Re: Zoning Board application resubmittal
Addition and alteration to
Existing 1 family dwelling
6 Fulton Street
Hastings on Hudson, New York
DAB Job # 160901

Attached please find 8 copies of revised drawings addressing comments of the last Zoning Board meeting. The attached package contains the original application package and revised drawing indicating the two (2) major concerns the Board, and adjacent neighbors voiced.

Proposed addition and alteration to
existing 1 family dwelling
6 Fulton Street
Hastings-on-Hudson, New York
66H-2-30

FIRST FLOOR PLAN

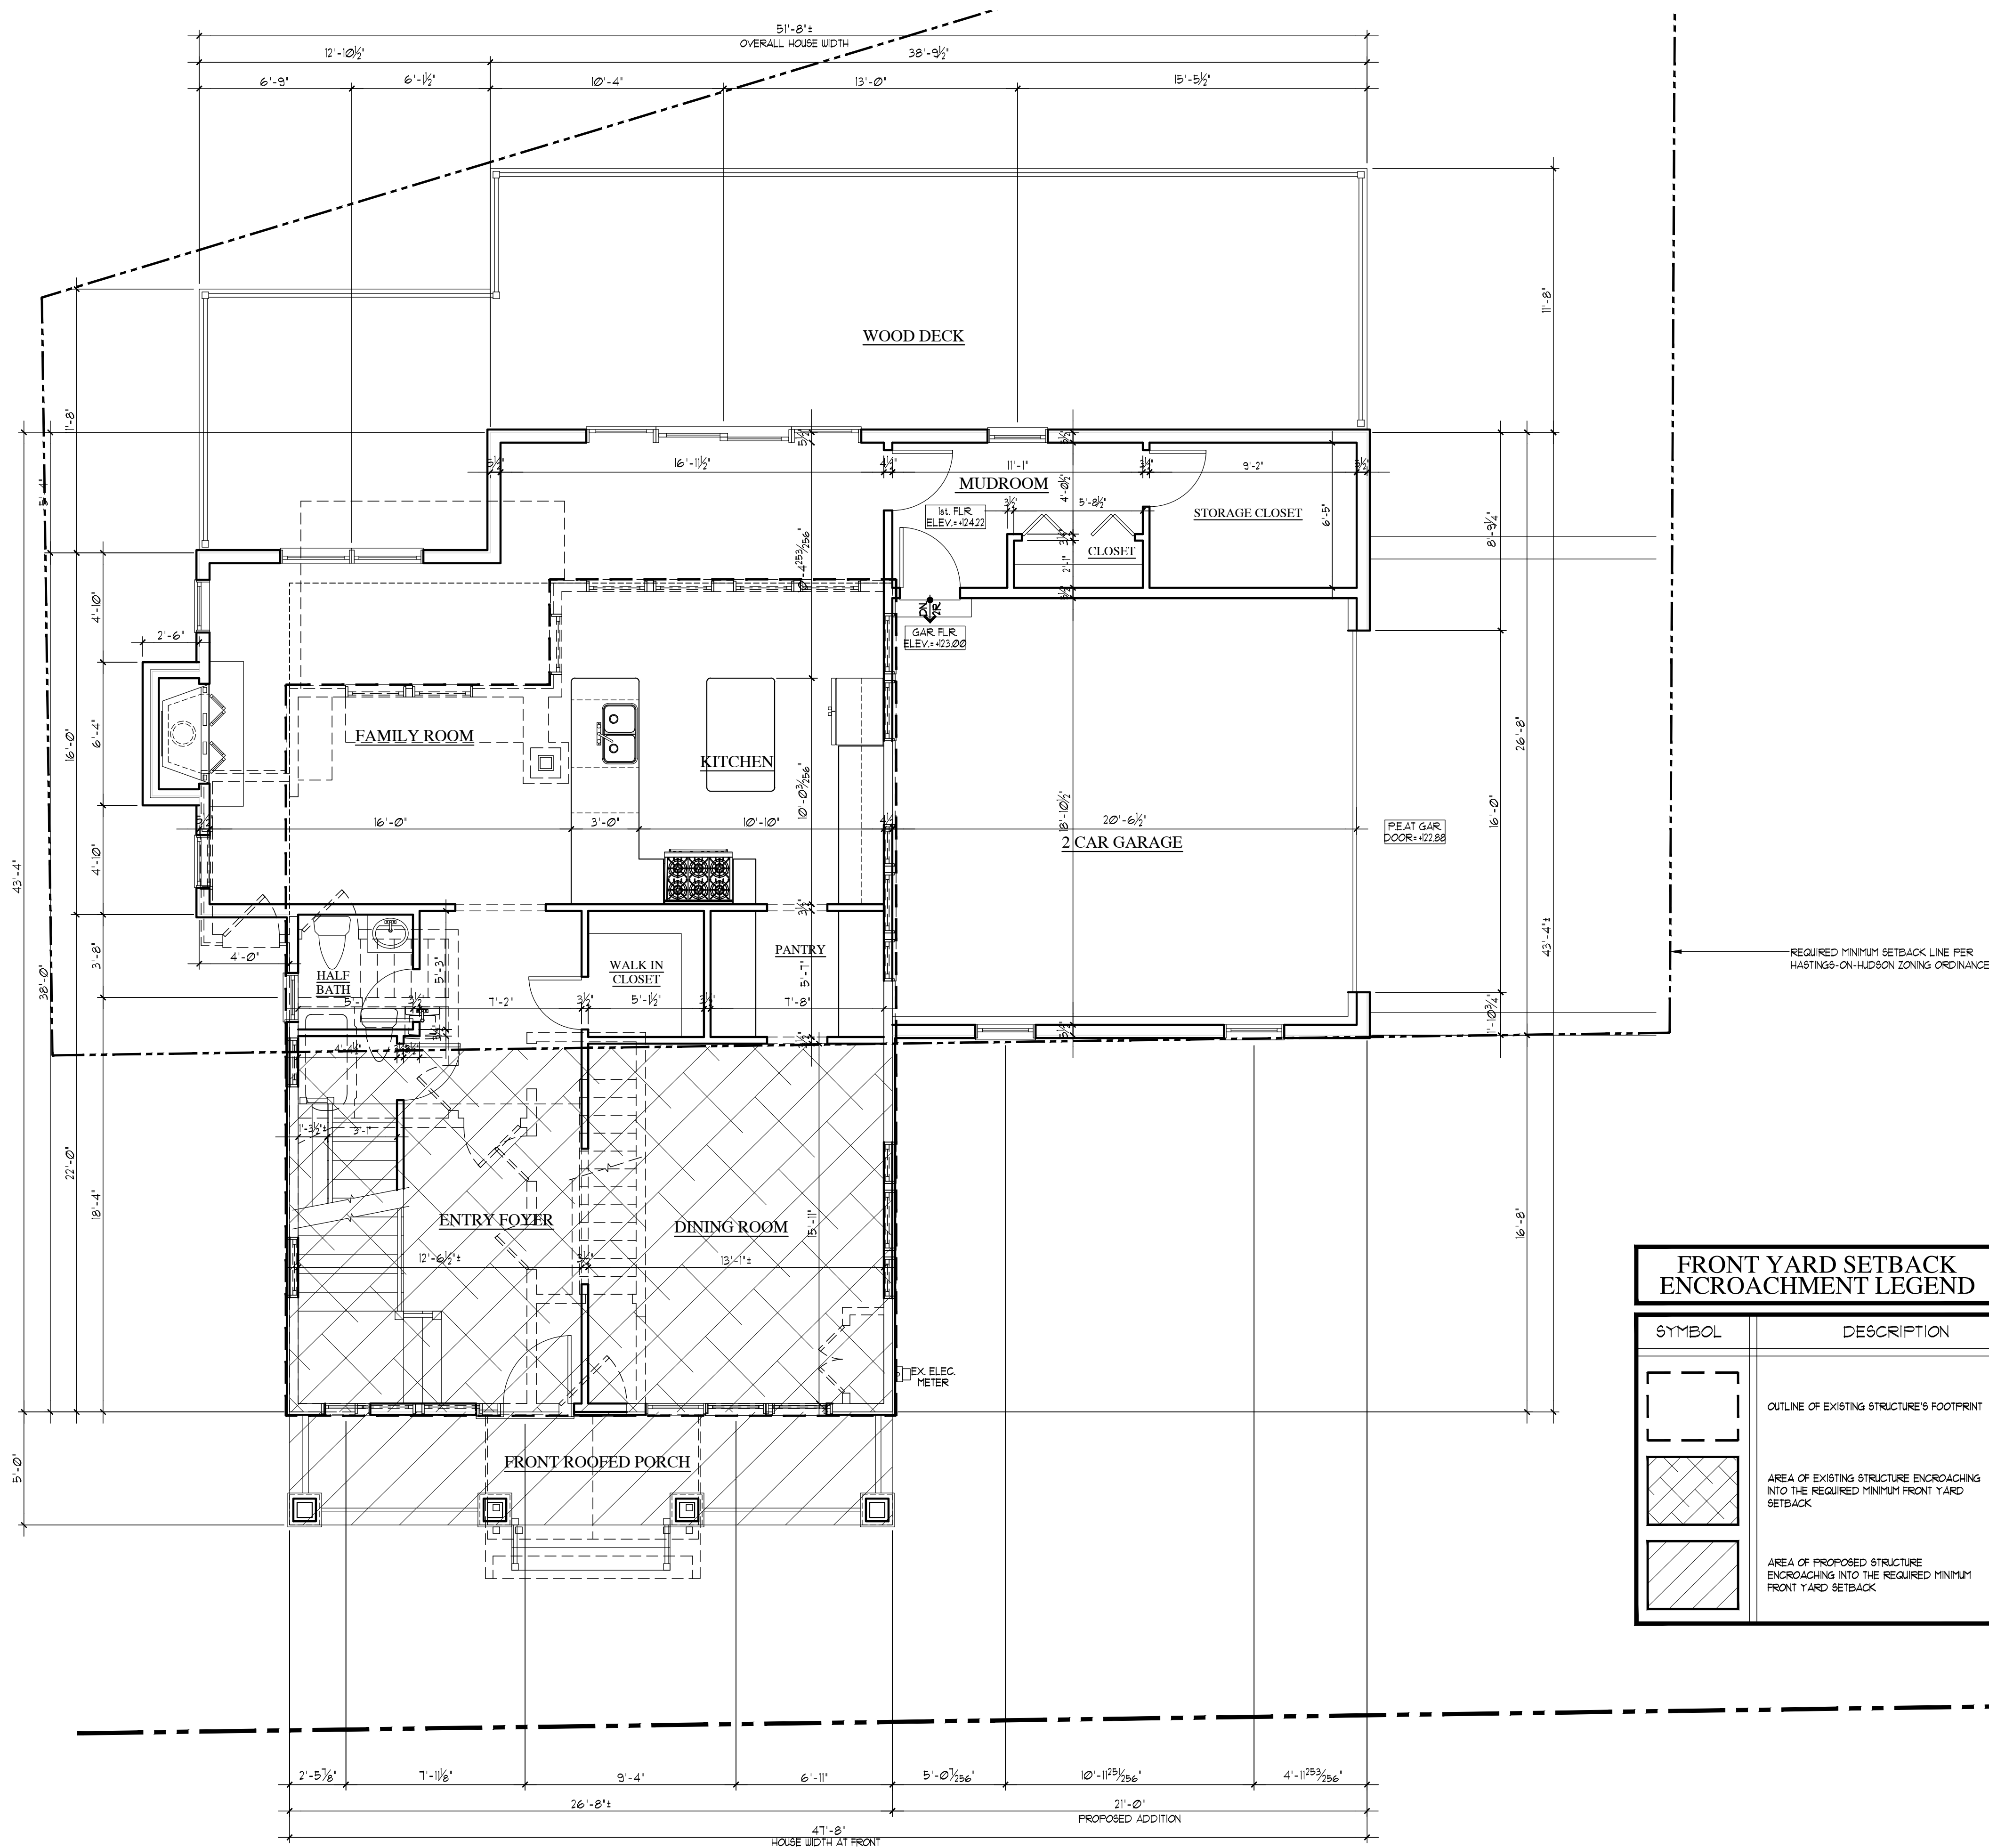
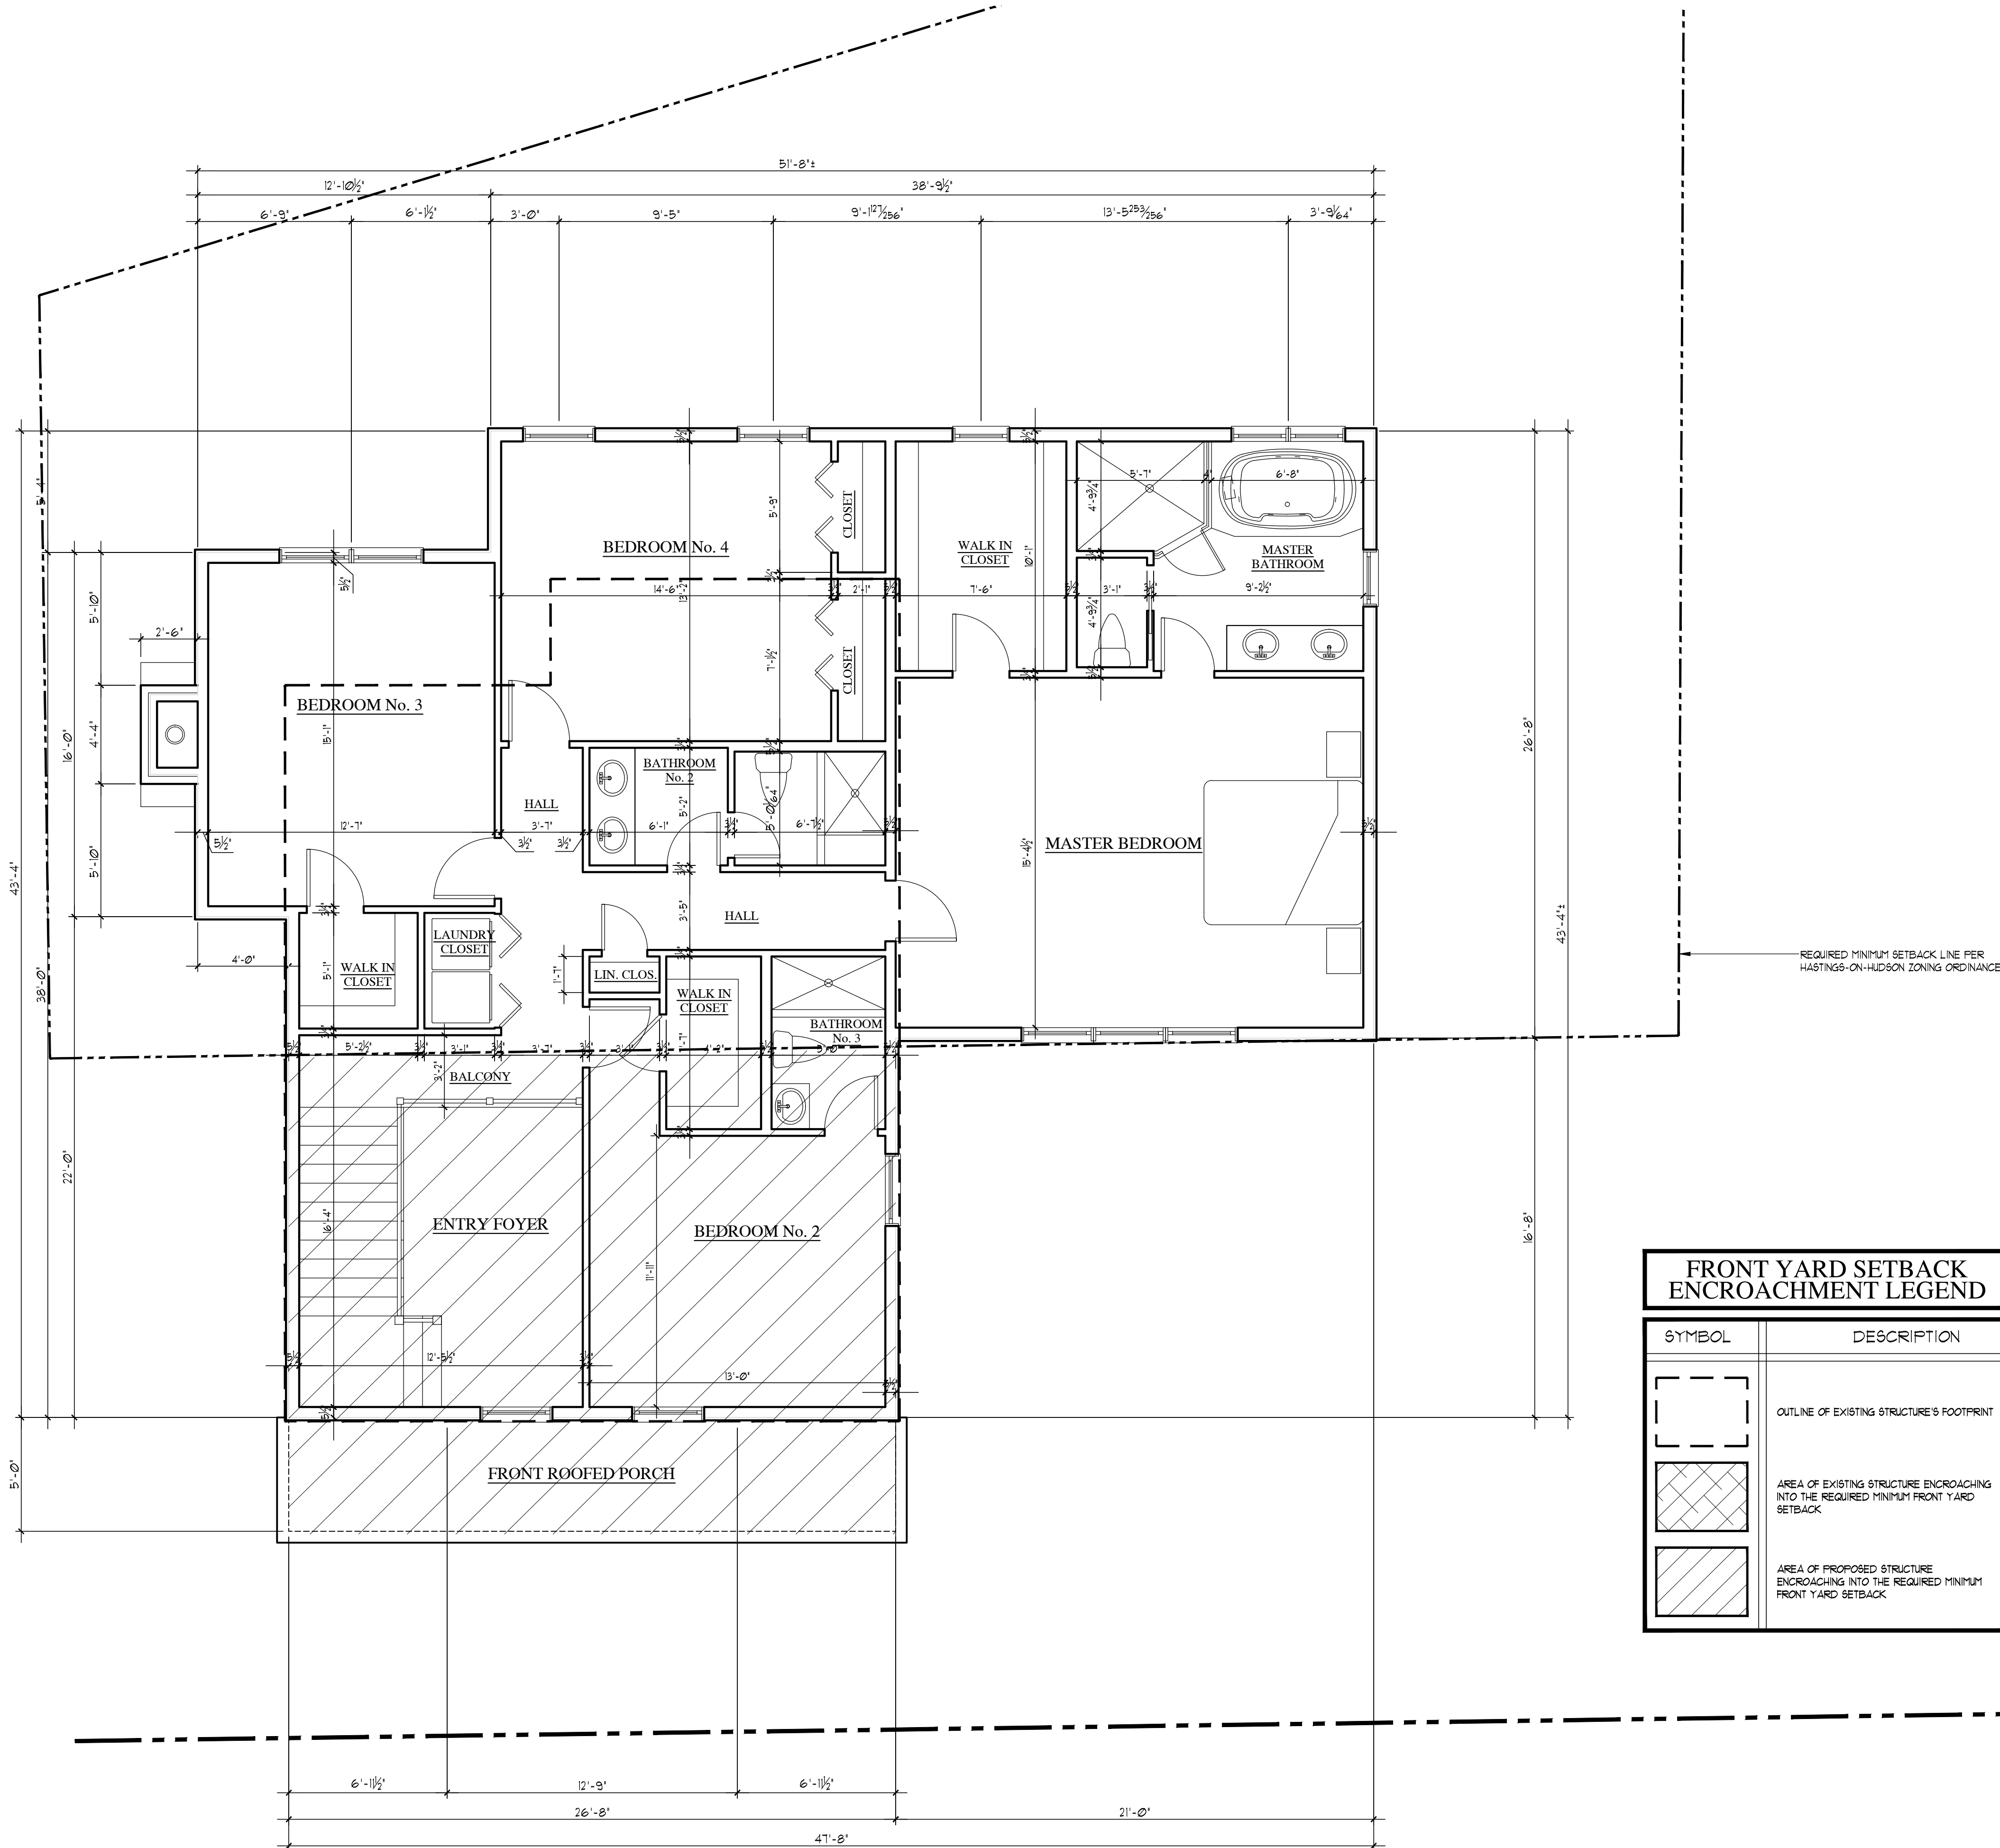
1. The proposed Garage addition at the right hand side, which was previously depicted as encroaching into the minimum front yard setback has been modified so that that part of the new structure will be completely beyond the minimum front yard setback.
2. The low wall that was proposed along a part of the westerly side of the driveway (approximately 3.5' high), has been modified. The Garage floor elevation has been lowered and the need for a wall has been reduced, as well as the height of the wall (2.0' at a small portion of the west side).

REV	DATE	DESCRIPTION
1	12-20-16	REVISED STORM WATER PLAN AND DETAILS PER ENGINEERING, P.C. DATED 12/23/16
2	12-14-16	REVISED HOUSE TO MOVE PROPOSED GARAGE WING TO BEHIND THE FRONT YARD SETBACK WALL HEIGHT TO SIDE NEIGHBOR
3	12-1-16	REVISED STORM WATER DRAINAGE SYSTEM AND GRADE AT PROPOSED HOUSE PER NEIGHBORS COMMENTS
4	11-21-16	REVISED ATTACHMENTS TO MAIN BUILDING HEIGHT COMPLY WITH MAX. BUILDING HEIGHT OF 35'-0" FROM LOWEST EXISTING GRADE PER HASTINGS ZONING CODE
